Category B	Technical	Ref. No. E056/07	Page 1 of 3
Coverage <input type="checkbox"/> Distributor only <input checked="" type="checkbox"/> Please inform your dealers		Date Issued December 18, 2007	
Please convey this information to your <input checked="" type="checkbox"/> Warranty Dept. <input checked="" type="checkbox"/> Parts Dept. <input type="checkbox"/> Director <input checked="" type="checkbox"/> Training Dept. <input checked="" type="checkbox"/> General Manager <input checked="" type="checkbox"/> Field Rep.		Date Revised	
Applicable Models Mazda3 (BK) with 1.3L Engine		Applicable Countries or Specifications Europe

Subject: Knocking or Chattering Sound from Engine When Cold

Piston Interference Point to the Cylinder Sidewall

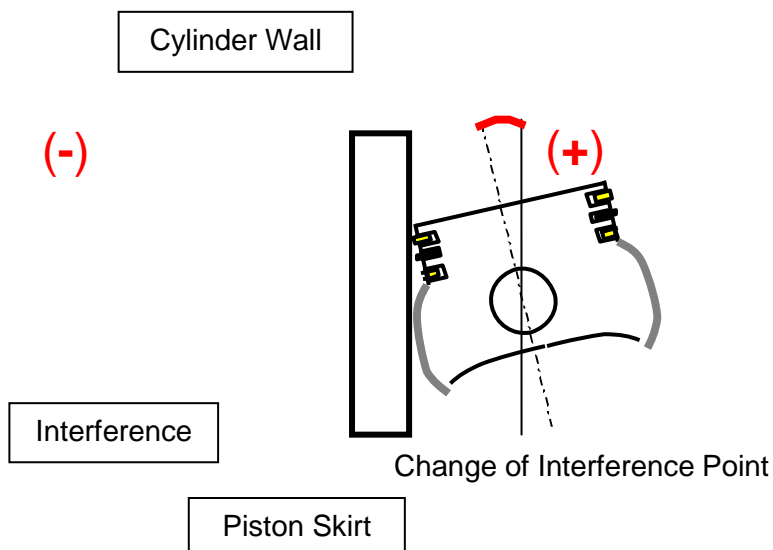
When the engine speed reaches approx. 1,000 – 1,500 rpm with the variable tumble shutter valve closed in a cold engine, the knocking or chattering sound occurs in the engine.

When the variable tumble shutter valve is closed, the intake airflow speed increases and rapid combustion occurs. The level of rapid combustion varies and, depending on that, the knocking / chattering sounds may be audible if the piston slightly touches the cylinder sidewall due to the enhanced combustion pressure.

This audible sound will not affect the engine performance / function. When the coolant temperature exceeds the specified setting (60 degrees Celsius), the variable tumble shutter valve stays open and the knocking / chattering sound stops.

If the customer is still complaining after the above explanation, please replace the pistons as per the Workshop Manual.

Then reprogram the PCM with Mazda Modular Diagnostic System (M-MDS) using the reprogram file IDS/PDS **51.8**, IDS/PDS **52.1** or later software.

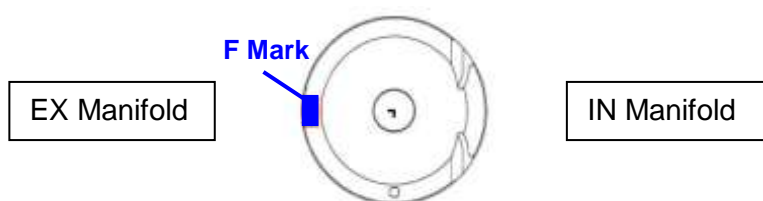
Note: Please replace all the four piston sets at the same time.

Note: The piston has "F" mark at the top.

Part No.		Part Name	Note
New	Old		
ZJY4 11 SA0	ZJY2 11 SA0A	Piston Set	Order 4 sets per vehicle. (One piston set includes one piston and one piston pin.)
ZJY4 11 SC0	ZJY1 11 SC0 ZJY2 11 SC0	Piston Ring Set	Order 1 set per vehicle. (One piston ring set includes 4 sets of top, 2nd and oil rings.)
